EXCEPTION RESOLUTION OF THE EXCEPTION REVIEW COMMITTEE

Miguel Zavaleta, Resource Protection Area (RPA) Encroachment Request #7171-WRPA-003-2, under Section 118-6-8(a) of the Chesapeake Bay Preservation Ordinance (CBPO), at 7780 Kelly Ann Court, Fairfax Station, to permit encroachment into the 2003 RPA for the construction of a swimming pool with concrete patio where the principal structure was established as of July 1, 1993, Springfield District, Tax Map #096-1-03-03-0012A. At a regular meeting of the Exception Review Committee (ERC) on February 7, 2018, Ms. Kanter moved that the ERC adopt the following resolution:

BRIARLYNN ESTATES - SECTION THREE - LOT 12A

GRADING PLAN

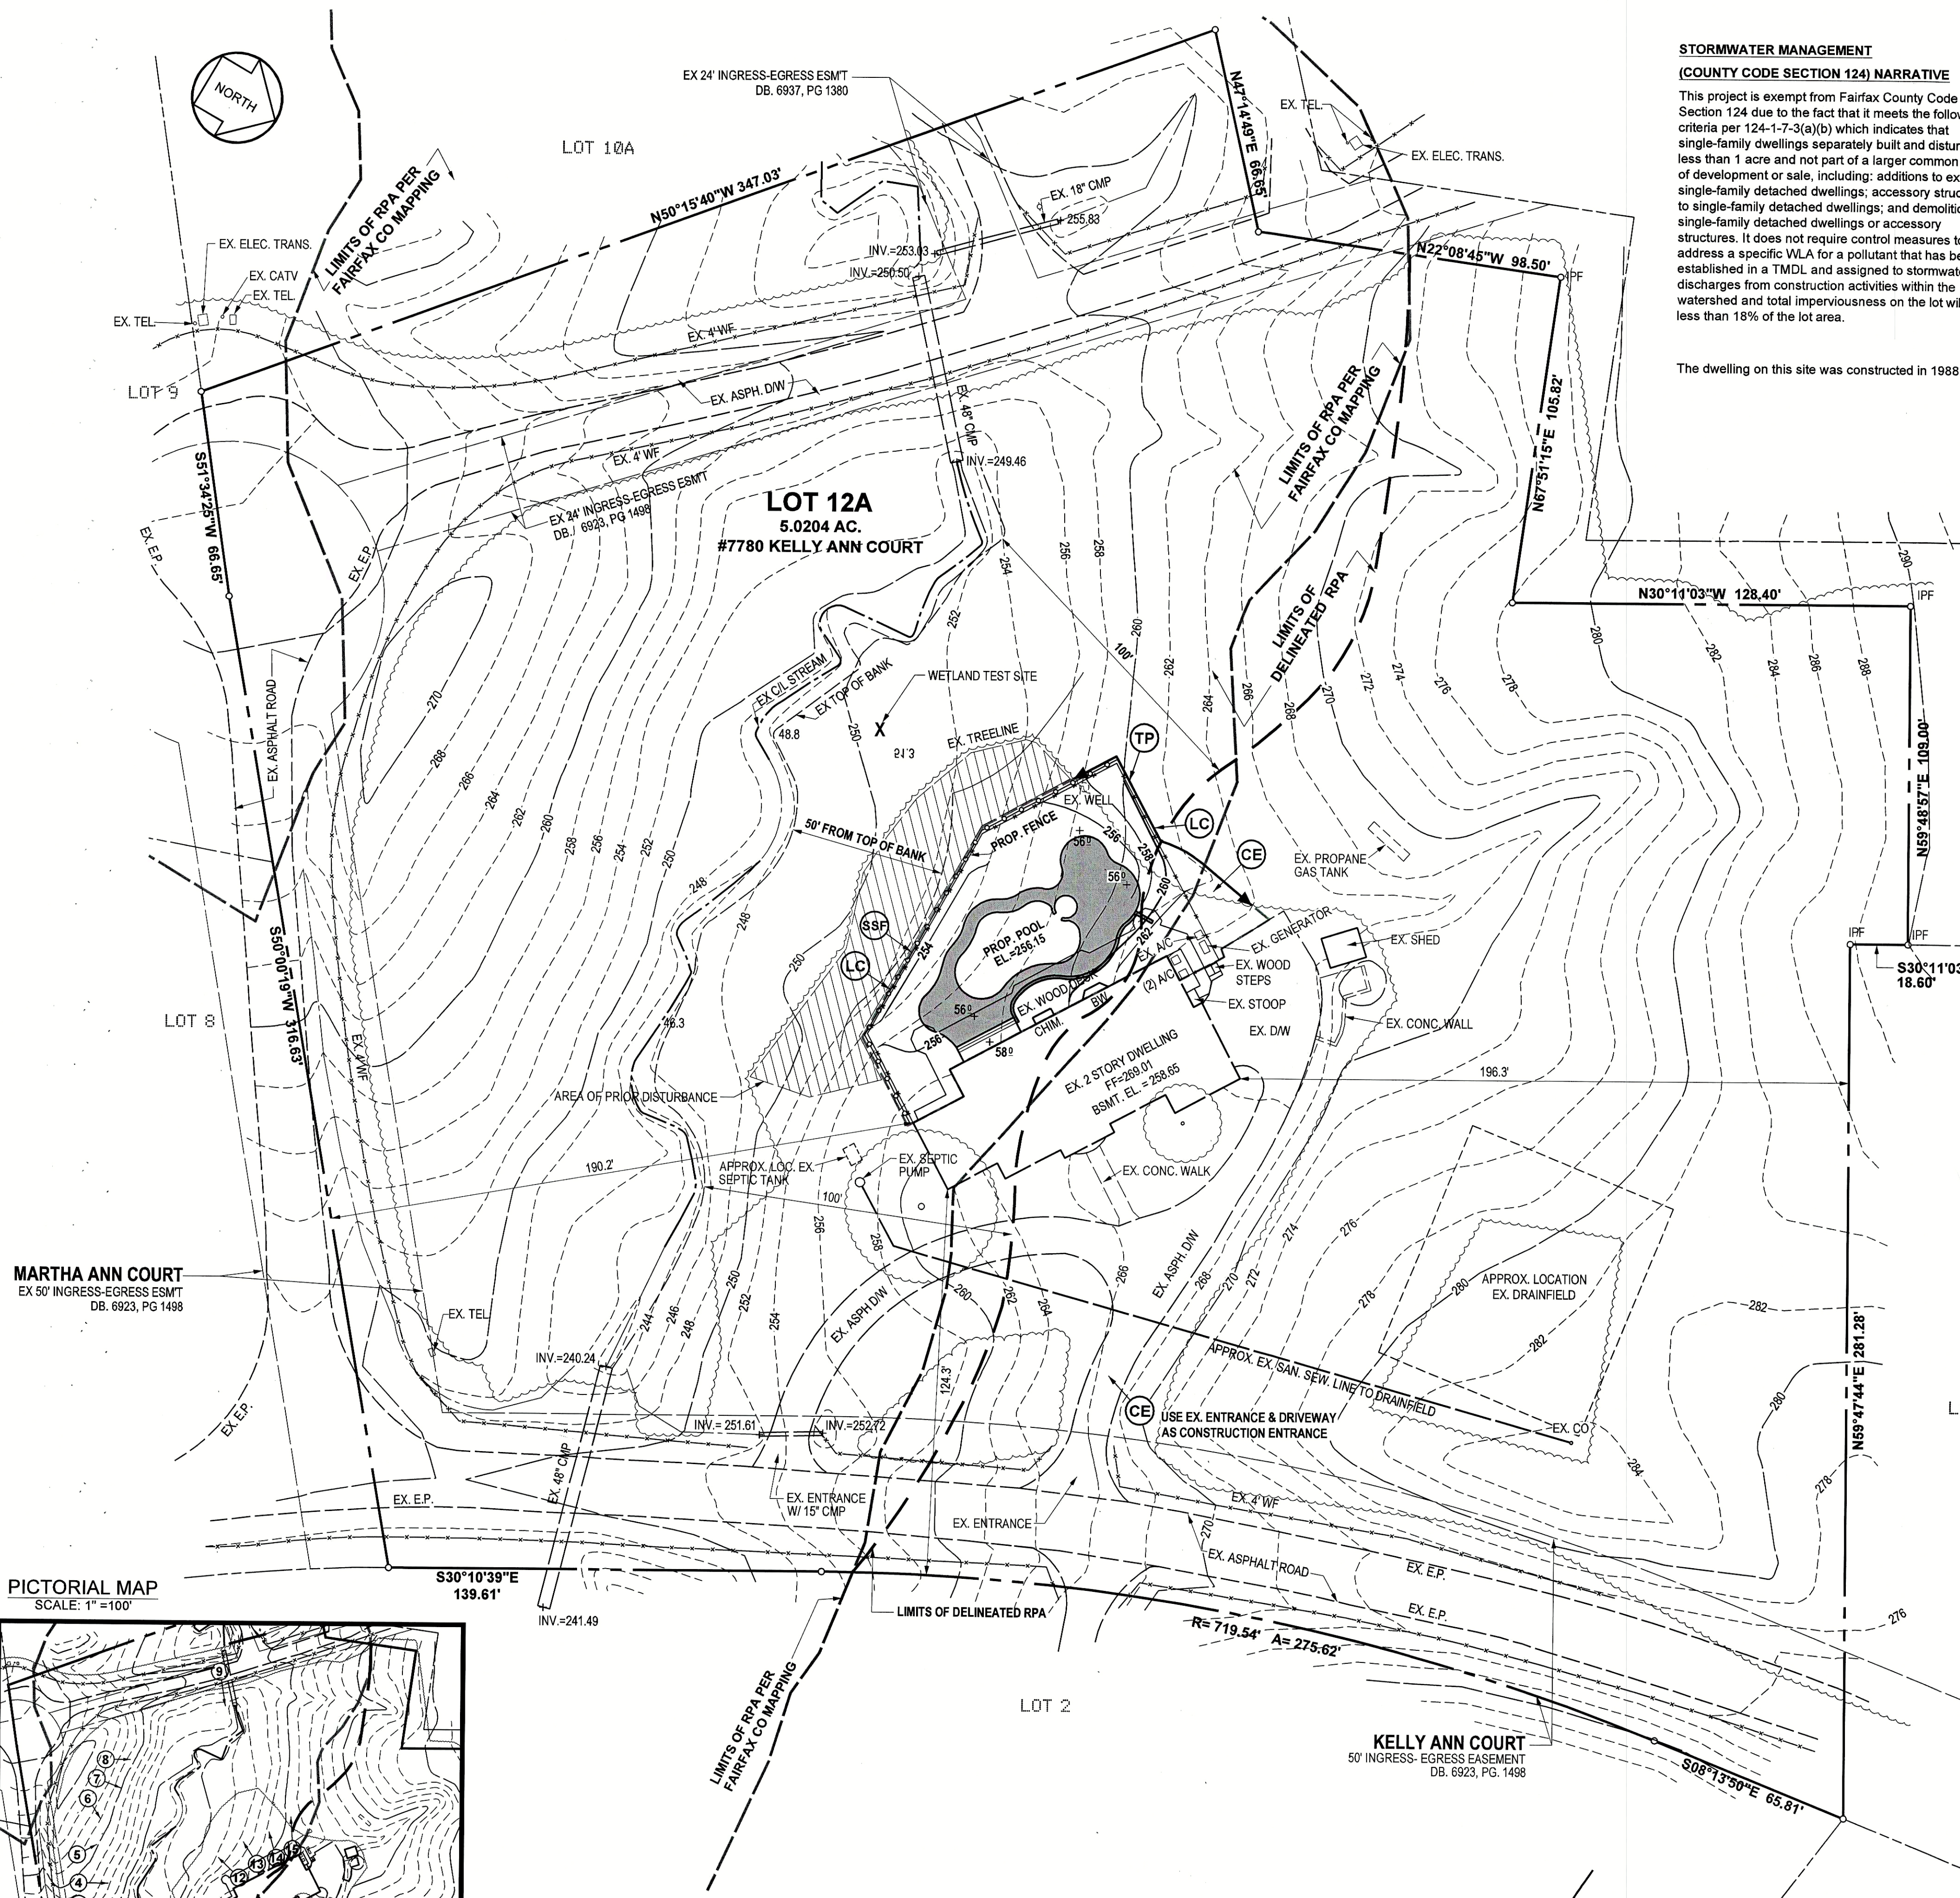
7. The impervious area of the concrete patio shall be reduced by a minimum of 10% within the RPA from the grading plan titled "Briarlynn Estates – Section three – lot 12A" prepared by Harold A. Logan Associates, PC, signed and sealed, received December 5, 2017.

8. The proposed mitigated areas shall be combined into a unitary form to the south side of the pool area. The proposed mitigation area to the west shall be relocated to the south of the proposed swimming pool.

TREE PRESERVATION PLAN

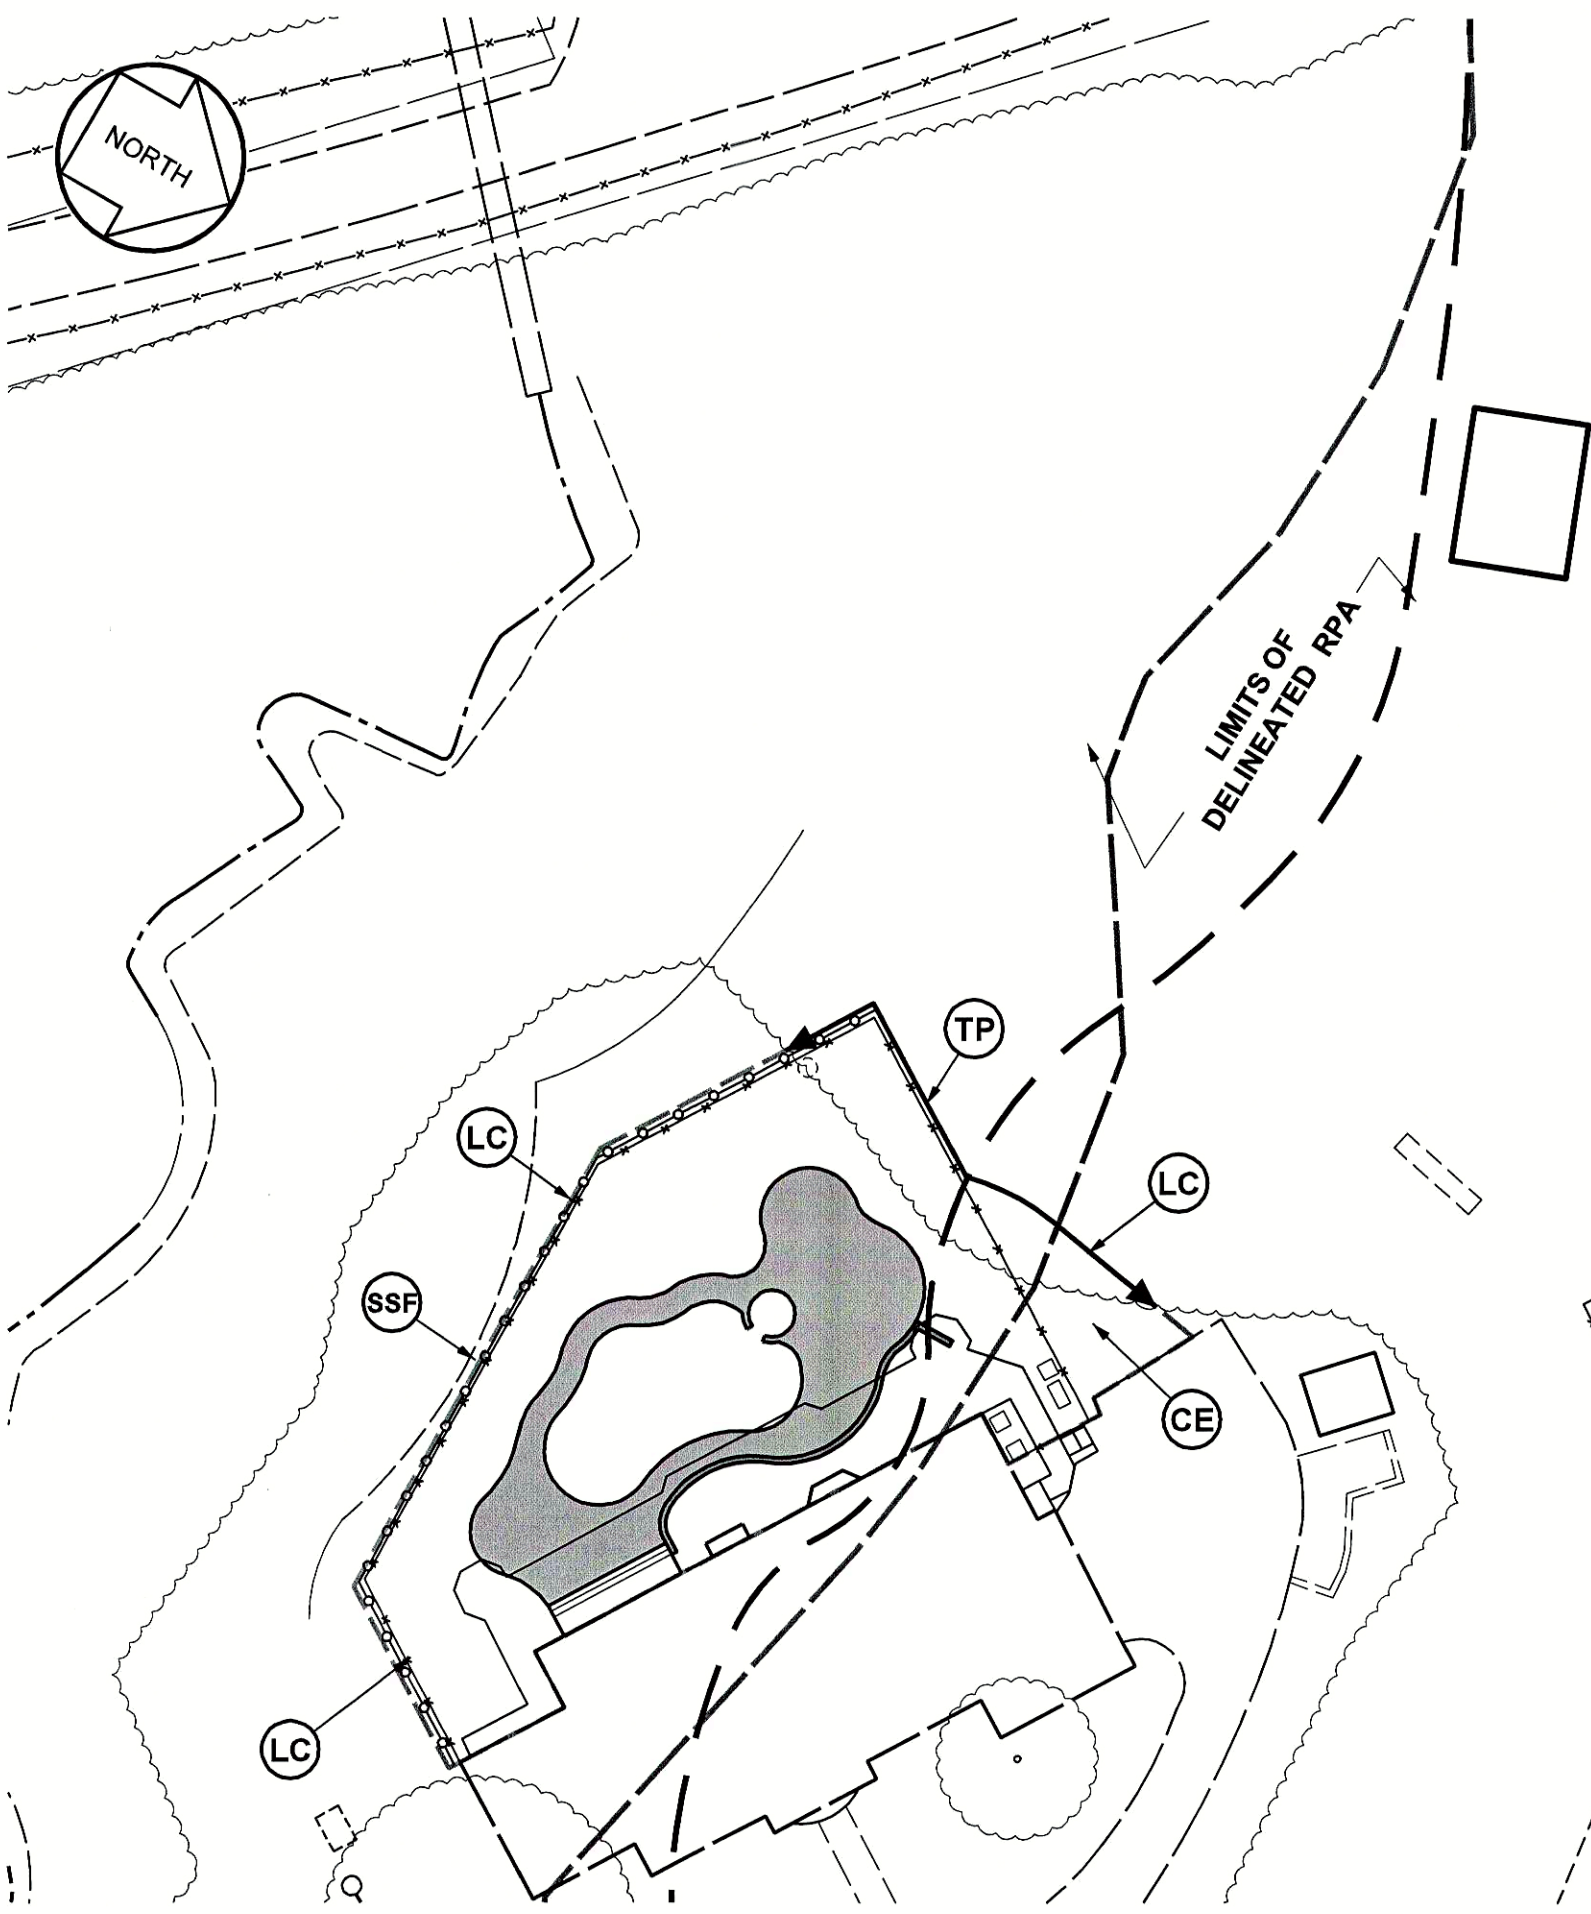
performance criteria for RPAs, vegetated buffer area(s) shall be established as generally shown on the tree preservation plan, date stamped December 5, 2017 with a combined area of at least 8,691 square feet. The size, species, density and locations shall be consistent with the planting requirements of CBPO Section 118-3-3(f), and PFM 12-0516.4 or a vegetation plan that is equally effective in retarding runoff, preventing erosion and filtering non-point source pollution from runoff, as determined by the Land Development Services (LDS) or the Urban Forest Management Division (UFMD). The Director may approve the use of a seed mixture as a supplement to or in lieu of individual plants for shrubs and groundcovers. Plants shall be native to the degree practical and adaptable to site conditions. The vegetation shall be randomly placed to achieve a relatively even spacing throughout the buffer. Notwithstanding any statements on the Plat and in the Water Quality Impact Assessment, the size, species, density and locations of the trees, shrubs and groundcover will be subject to approval by the Director of LDS or UFMD.
